When replacing the drive end housing on the N1506-1 alternator, follow Figure 1 to remove the proper through-stud on drive end of shell/stator/field coil assembly.

The new N7485 drive end housing has molded B+ studs and will require the through-stud shown in Figure 1 to be removed to fit the new housing.

Figure 1 — Through-stud Removal

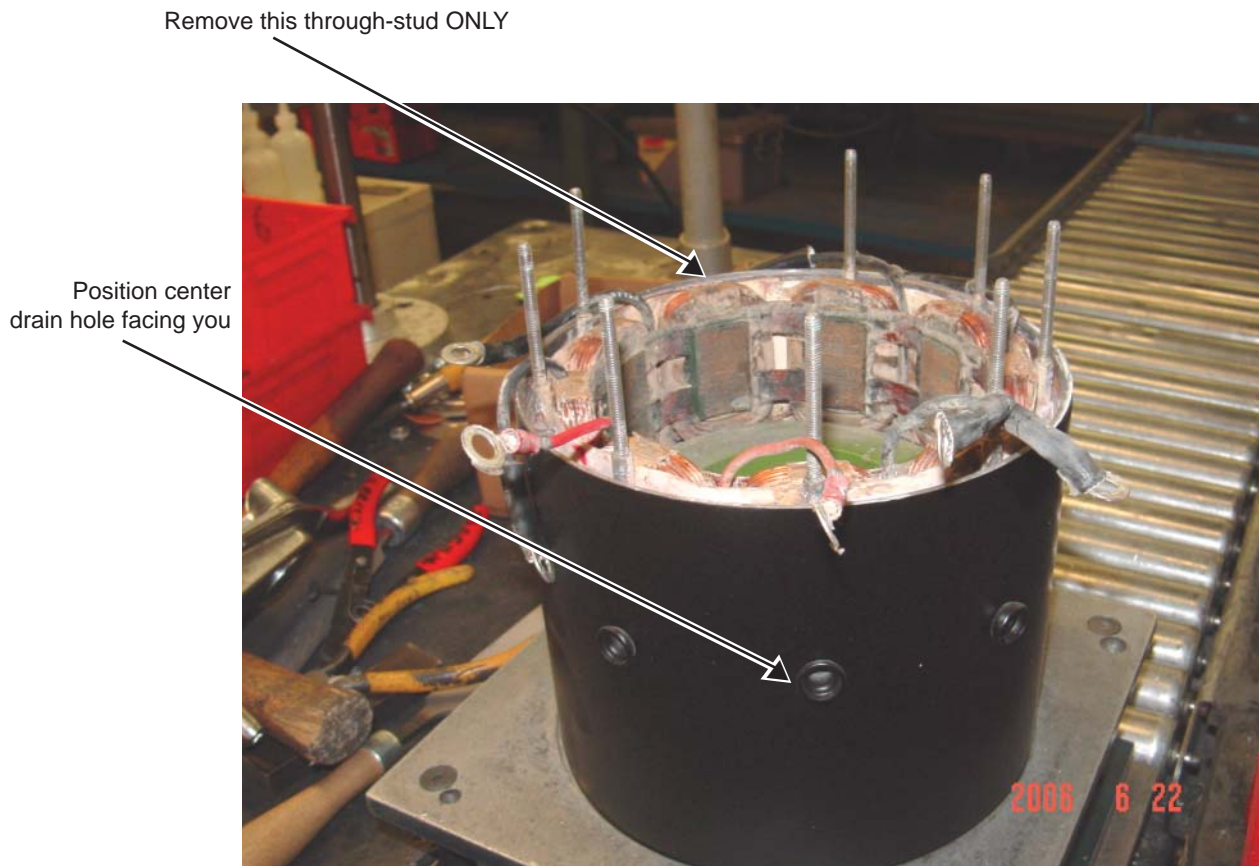
Use caution when removing through-stud to prevent damaging stator windings.

Figure 2 — Setting New Drive End Housing in Position

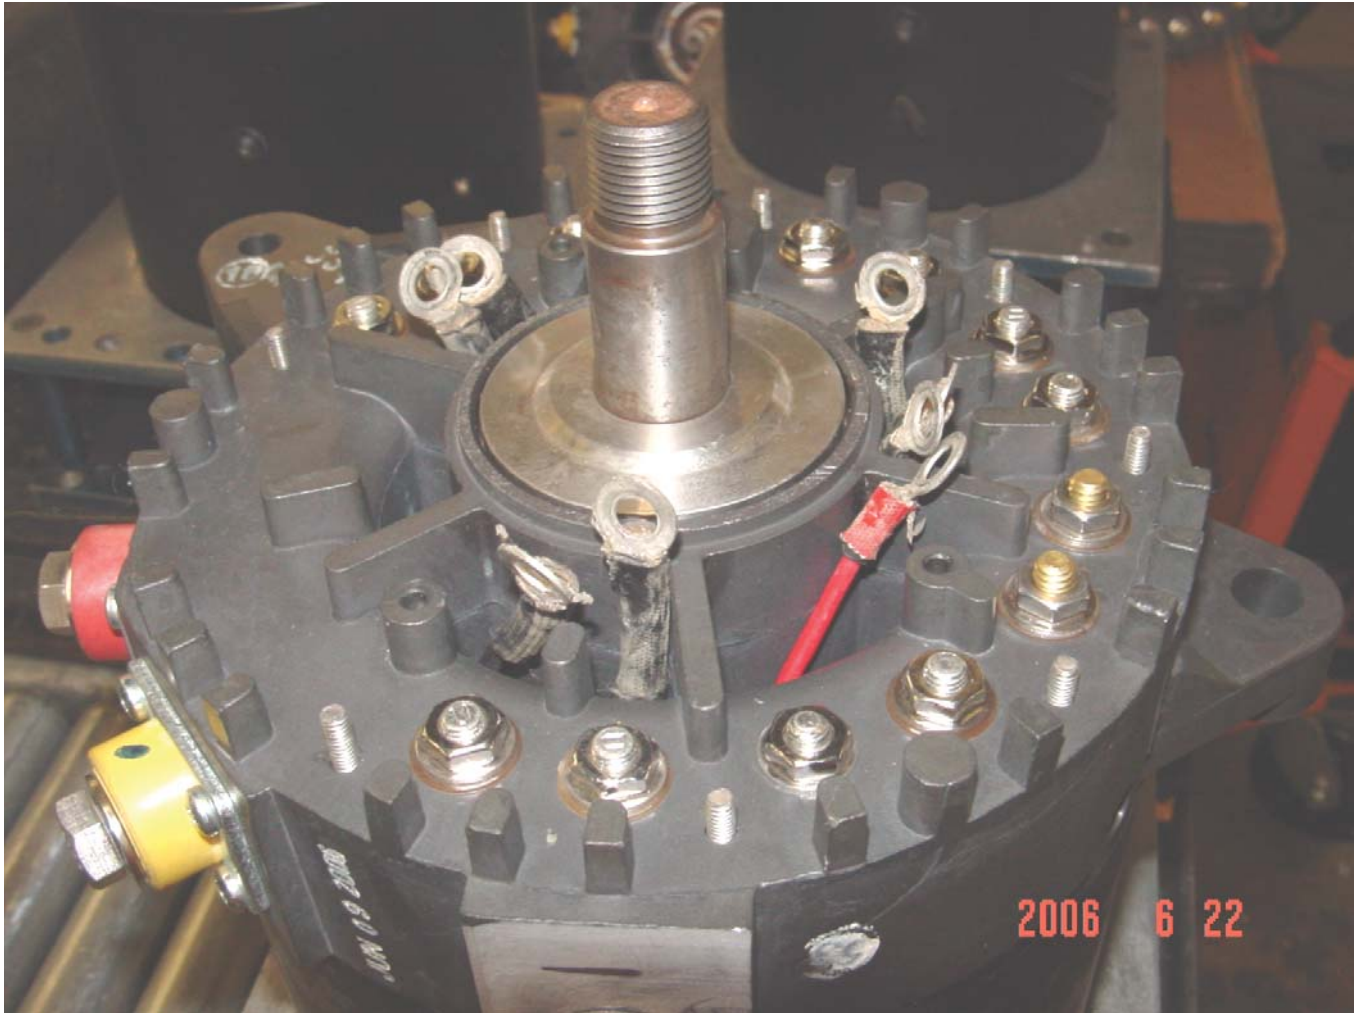
Position new drive end housing over remaining 8 through-studs as shown in Figure 2.

Torque values for connections:

Phase lead nuts—30 lb. in.

Field coil lead nuts—30 lb. in.

Through-stud nuts—45 lb. in.

28 V B+ terminal nut—80 lb. in.

14 V B+ terminal nut—80 lb. in.

B- terminal bolt—80 lb. in.
